# ADDENDUM

ADDENDUM NO: 2

Project: Gurnee Public Works Fleet Garage Renovation  
1151 Kilbourne Road  
Gurnee, IL 60031

Project Number: 26-4519.01

**NOTATION PLAN**  
 SHEET NO.  
**A1.10**  
 JOB NO. 26-4519-01  
 © 2026 FGM Architects

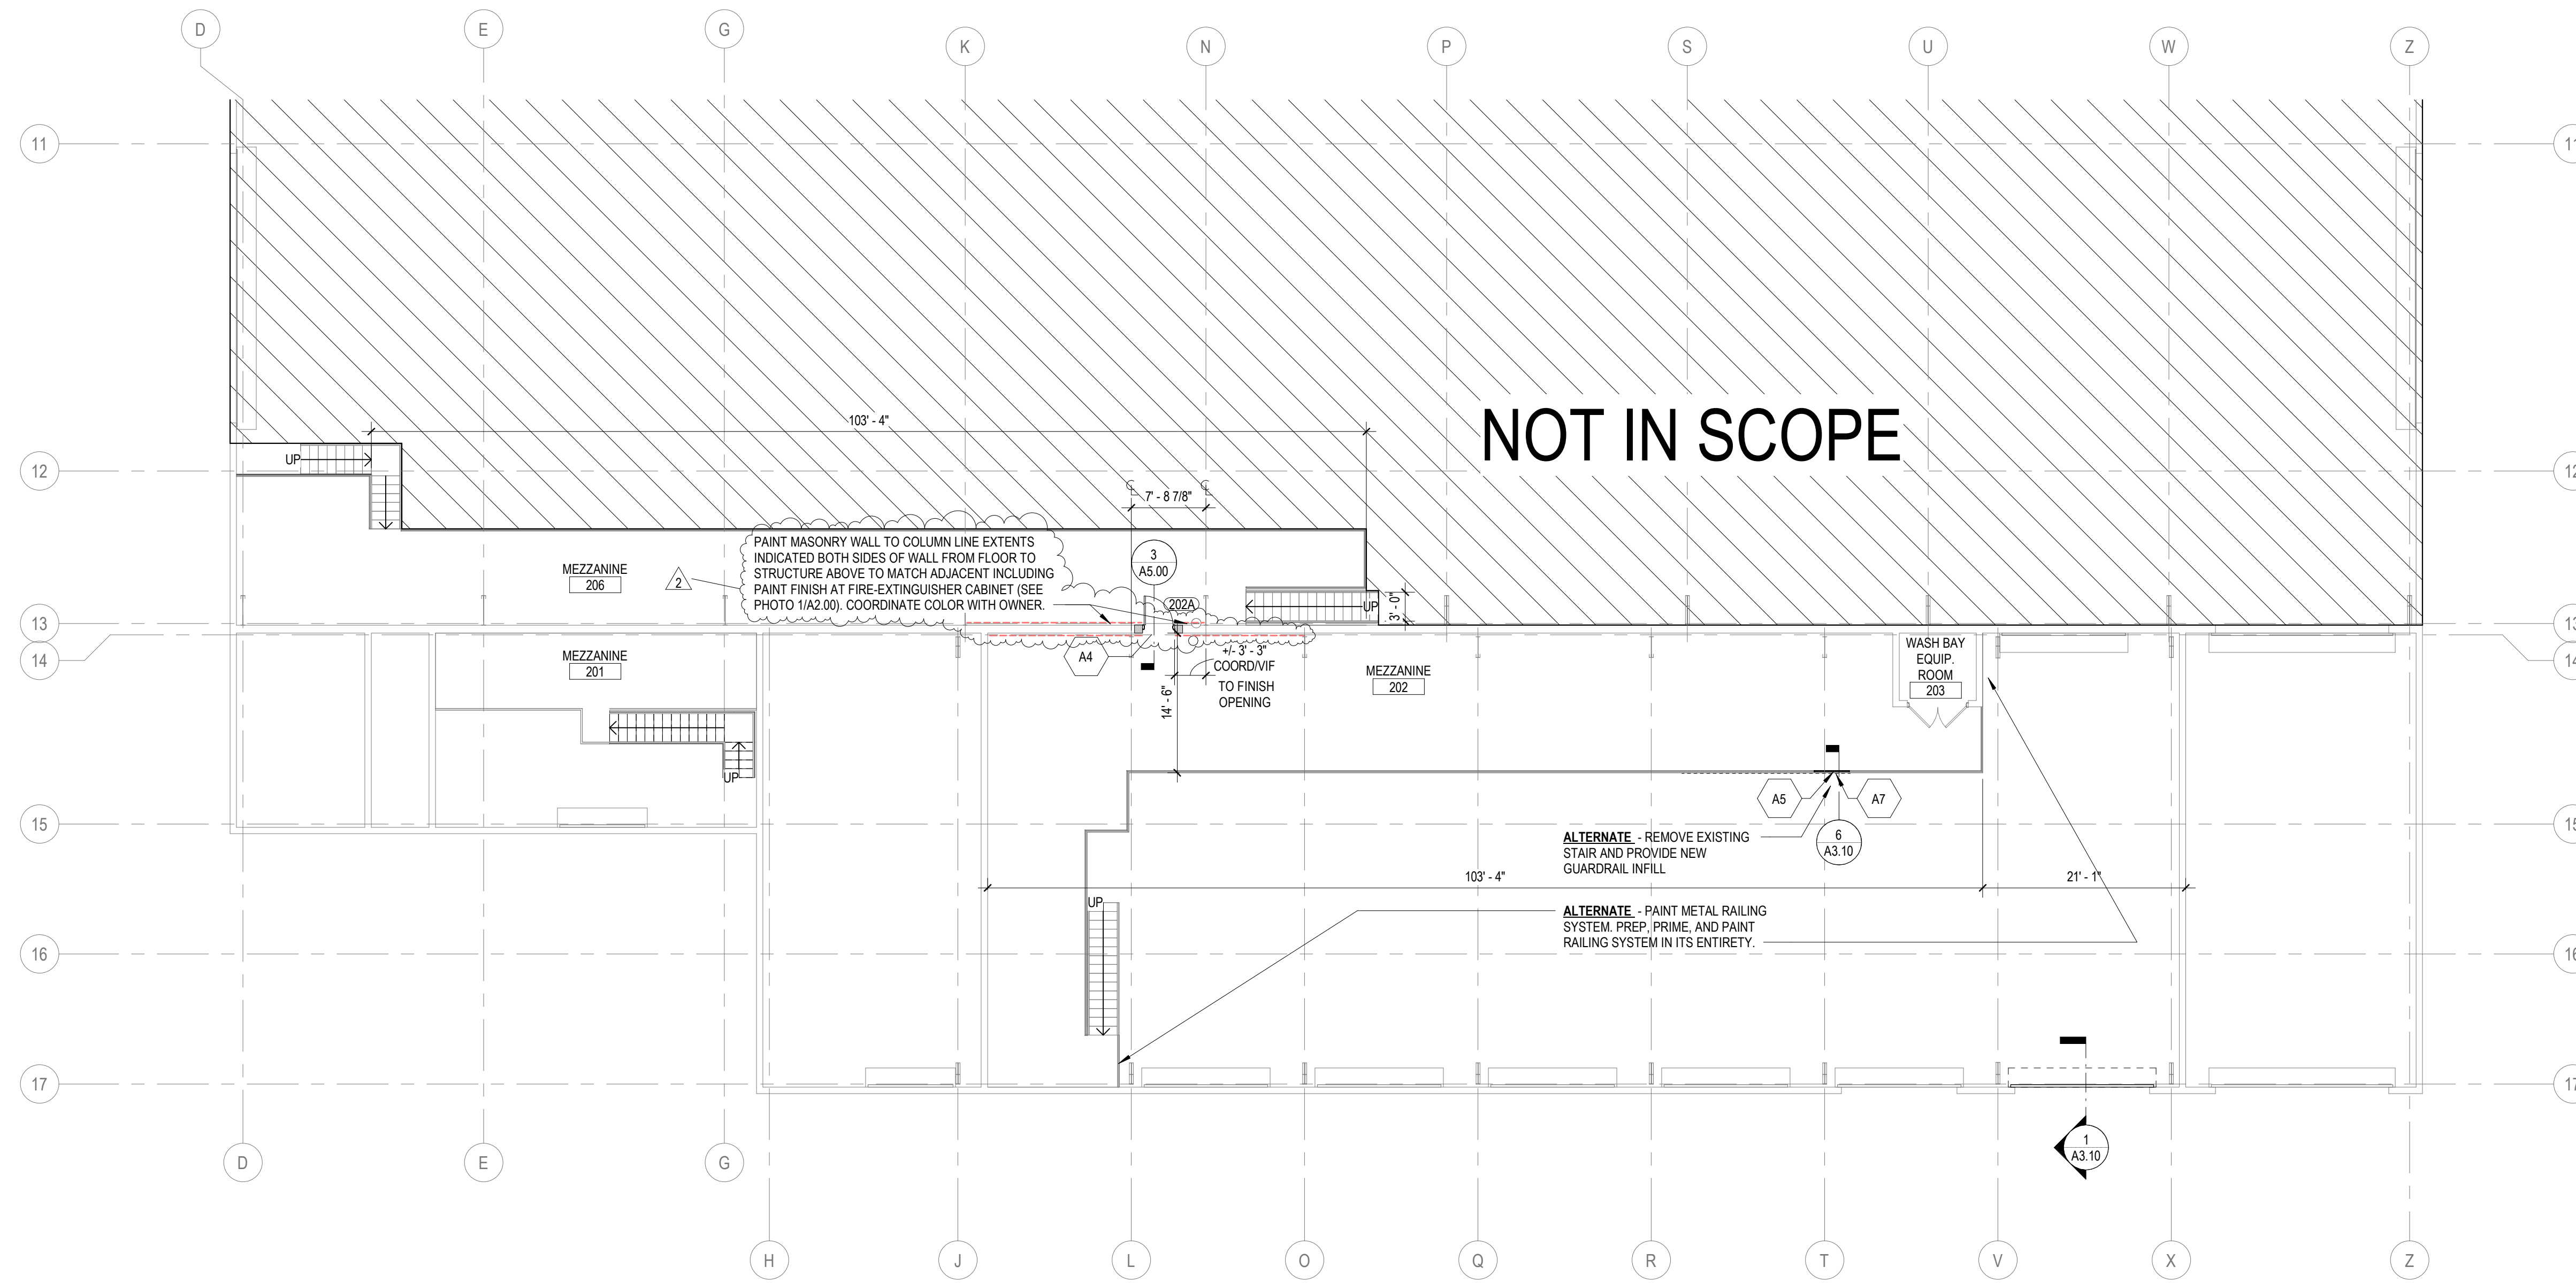
A1.10	Paint clarification per response to Camosy Construction RFI.
-------	--------------------------------------------------------------

RFI #	Status	Description of RFI	Discipline	Responded to (Addendum # & date)
1.1		<p>The only paint indicated in the drawings is one door/frame. Where would I find finish information?                      There appears to be more painting than just the door and frame.                      Masonry                      Misc. Steel                      Railing alternate                      Please provide finish information for all of the above.</p>	Arch.	<p><b>Railing infill to be painted as indicated in Dtl 6, A3.10 and Alt #1 Spec Section 01 10 01 which also clarifies painting portion of exposed CMU wall at stair removal and guardrail.</b>  <b>Steel at new garage door opening to be painted per details A3.10 and A5.00. A note has also been added to revised plan 1/A1.10.</b>  <b>Extent of paint at CMU wall at new mezzanine level door opening is indicated on revised plan 2/A1.10.</b>  <b>Refer to revised Keyed note A10 and revised general note 5 on A1.10 for paint clarification notes.</b></p> <p><b>Refer to Revised Sheet A1.10.</b></p>

- GENERAL FLOOR PLAN NOTES**
- REFER TO G-SERIES SHEETS FOR TYPICAL ABBREVIATIONS, SYMBOLS & TAGS.
  - WALL AND PARTITION DIMENSIONS ARE SHOWN TO FINISHED FACE OF WALL.
  - PROVIDE HORIZONTAL JOINT REINFORCING AT ALL MASONRY PARTITIONS. PROVIDE JOINT REINFORCING @ EACH SECOND COURSE AND ONE COURSE BELOW AND ABOVE OPENINGS UNLESS NOTED OTHERWISE. REFER TO STRUCTURAL DRAWINGS FOR ADDITIONAL REINFORCING.
  - FOR EXTERIOR WALL ASSEMBLY TYPES AND MATERIALS, SEE EXTERIOR WALL SECTIONS AND DETAILS ON A3 AND A4 SERIES DRAWINGS.
  - PATCH/REPAIR ALL ADJACENT SURFACES TO MATCH CONSTRUCTION (PREP AND TOUCH-UP PAINT AS REQUIRED TO MATCH ADJACENT).
